### THE SERVICED GRID CODE – ISSUE 4 REVISION 1

**THE GRID CODE – ISSUE 4 REVISION 2**

## THE GRID CODE – ISSUE 4 REVISION 2

### SUMMARY OF CHANGES

**POWER PARK MODULE PERFORMANCE CHART  
AT THE CONNECTION POINT OR USER'S SYSTEM ENTRY POINT**

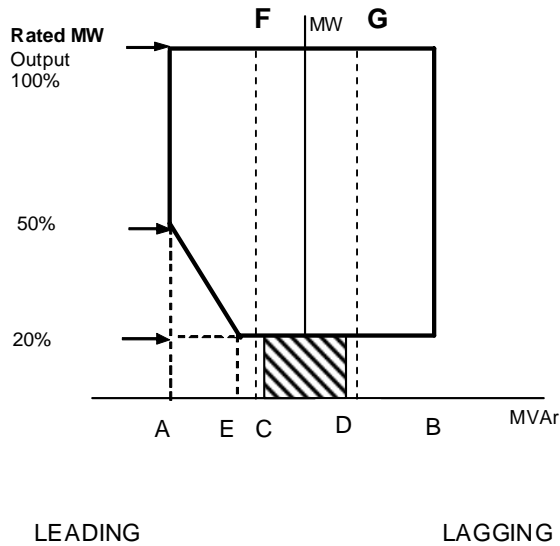
Where a **Reactive Despatch Network Restriction** is in place which requires following of local voltage conditions, alternatively to (E), please check this box.

- Point A is equivalent (in MVAR) to: 0.95 leading **Power Factor** at **Rated MW** output
- Point B is equivalent (in MVAR) to: 0.95 lagging **Power Factor** at **Rated MW** output
- Point C is equivalent (in MVAR) to: -5% of **Rated MW** output
- Point D is equivalent (in MVAR) to: +5% of **Rated MW** output
- Point E is equivalent (in MVAR) to: -12% of **Rated MW** output
- Line F is equivalent (in MVAR) to: Leading **Power Factor Reactive Despatch Network Restriction**
- Line G is equivalent (in MVAR) to: Lagging **Power Factor Reactive Despatch Network Restriction**
